UNITED STATES PATENT AND TRADEMARK OFFICE

APPLICATION NO.	FILING DATE	FIRST NAMED INVENTOR	ATTORNEY DOCKET NO.	CONFIRMATION NO.
10/590,284	04/19/2007	Anwar Abumustafa	688.1076	8086
23280	7590	07/06/2011		
Davidson, Davidson & Kappel, LLC 485 7th Avenue 14th Floor New York, NY 10018			EXAMINER BAYOU, AMENE SETEGNE	
			ART UNIT 3746	PAPER NUMBER
			MAIL DATE 07/06/2011	DELIVERY MODE PAPER

DETAILED ACTION

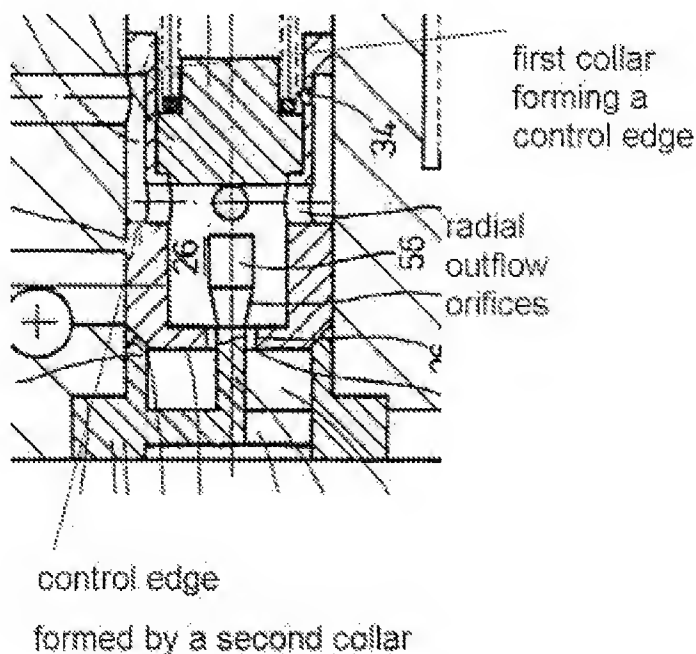
In re claim 7 Nguyen et al. disclose a valve assembly including:

A pump comprising: **a flow-control valve device (figure 1;column 1,lines 5-12) including a piston (16;figure 1) displaceably accommodated within a piston bore , the piston bore having at least one inflow channel (36) and at least one outflow channel (32) , and the piston (16) having an axial inflow orifice (26) and a plurality of radial, lateral outflow orifices (28) and a circumferential outflow groove (30) disposed between a first collar (see below) and a second collar (see below), the second collar forming a control edge (see below) for an outflowing fluid flow, the axial inflow orifice (26) extending cylindrically at least to a beginning of the radial, lateral outflow orifices (28) .**

Nguyen et al.'s **outflow groove (30)** does not expand in terms of a radial depth on an outer surface of the piston.

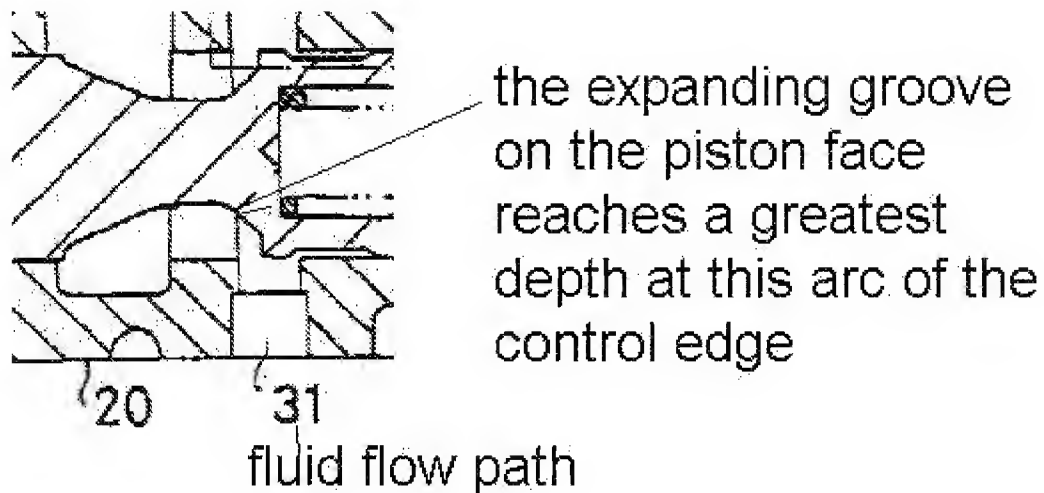
Nirasawa et al. teach a hydraulic valve wherein **a circumferential outflow groove (44; figure 2A and 2B)** expanding in terms of a radial depth on an outer circumference of the piston (40) towards the control edge.

It would have been obvious to one skilled in the art at the time the invention was made to modify the valve of Nguyen et al. by making the circumferential outflow groove to expand in terms of radial depth up to a control edge as taught by Nirasawa et al in order to have smooth flow transition between the discharge orifice and an outlet connection (the curved surface reduces flow resistance and accompanied flow loss is reduced).

The **outflow groove (44; figure 2A and 2B)** expands in a conical form on a piston side and, as the result of a radially, inwardly directed arc, subsequently reaches a greatest depth in a region of the control edge .
